The amendment would revise the Technical Specifications to incorporate new heatup and cooldown limitation curves.

H. B. ROBINSON STEAM ELECTRIC PLANT, UNIT NO. 2

AMENDMENT TO FACILITY OPERATING LICENSE

Amendment No.82
License No. DPR-23

FIGURE 3.1-1

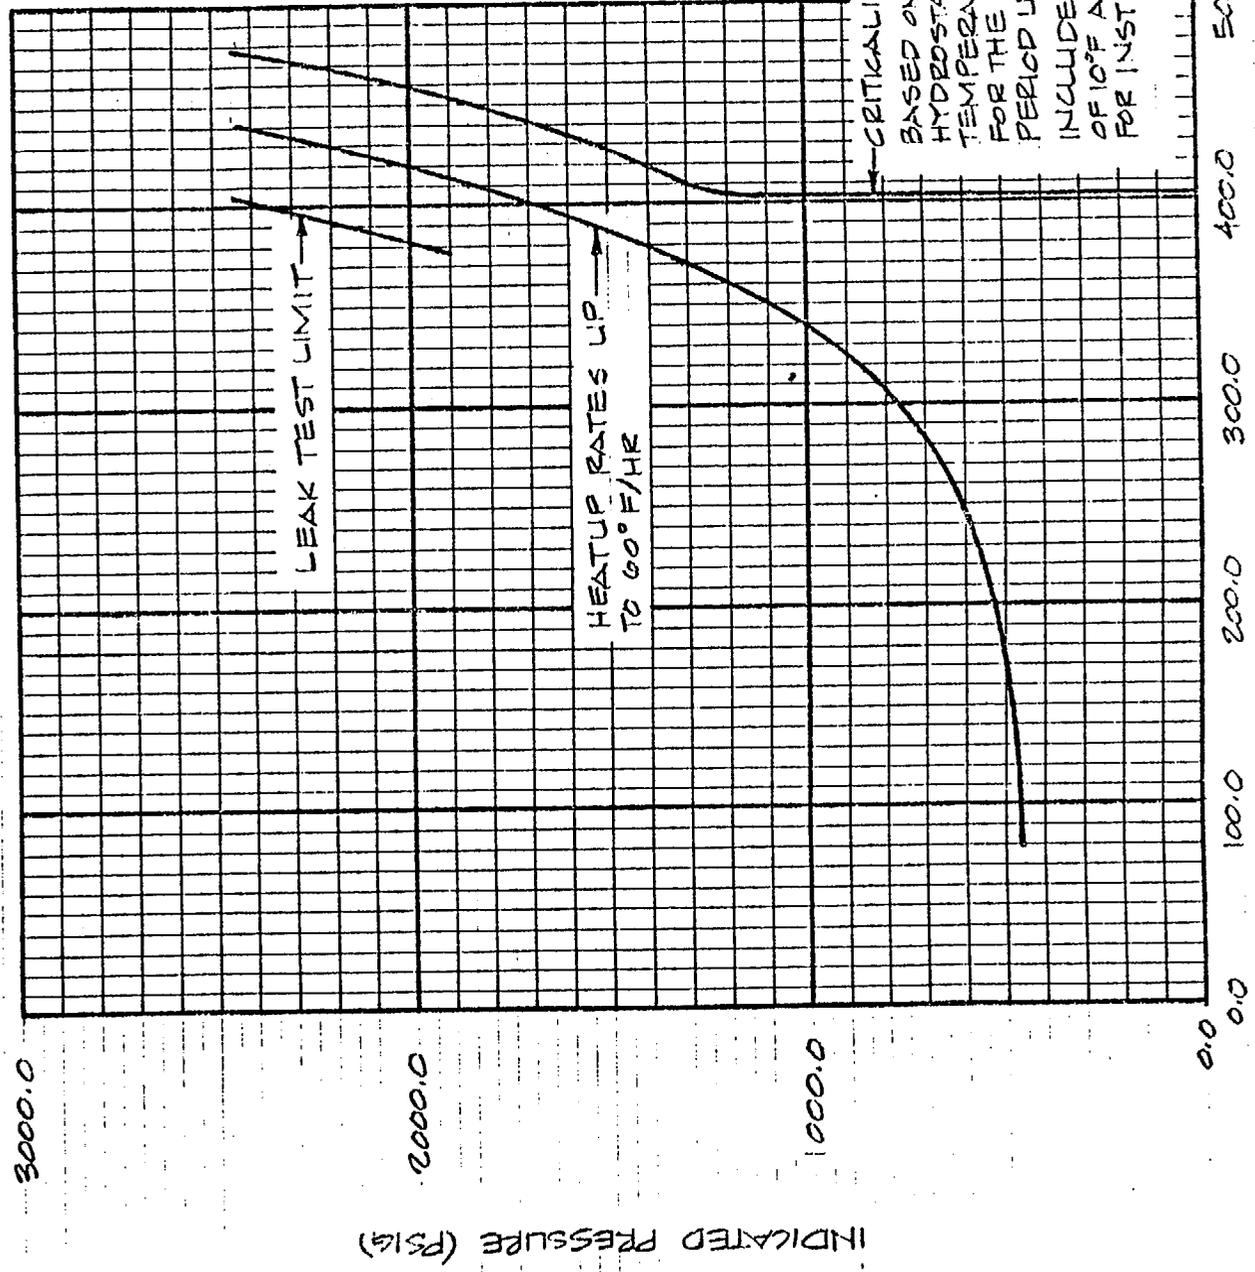
In letter from M. A. Mc Duffie to S. A. Varga dated October 14, 1983, the Carolina Power & Light Company (CPLC) requested a change to the H. B. Robinson Steam Electric Plant Unit No. 2 (HBR-2) reactor vessel pressure temperature limits, Figures 3.1-1 and 3.1-2 of the plants technical specifications. CPLC indicates that the pressure-temperature limits will meet the requirements of Appendix G, 10 CFR 50, for a period of time corresponding to 10 effective full power years (EFPY).

We have used the unirradiated RT_{NDT} for beltline and closure flange materials, which were previously discussed, the neutron fluence estimates of the licensee, the Regulatory Guide 1.99 Rev. 1 method of estimating neutron irradiation damage, and Standard Review Plan 5.3.2 method of calculating pressure-temperature limits to evaluate the applicant's proposed pressure-temperature limits. Our evaluation indicates that the proposed pressure-temperature limit curves meet the safety margins of Appendix G, 10 CFR 50, for a period of time corresponding to 10 EFPY. Hence, the proposed curves may be incorporated into the HBR-2 Technical Specification.
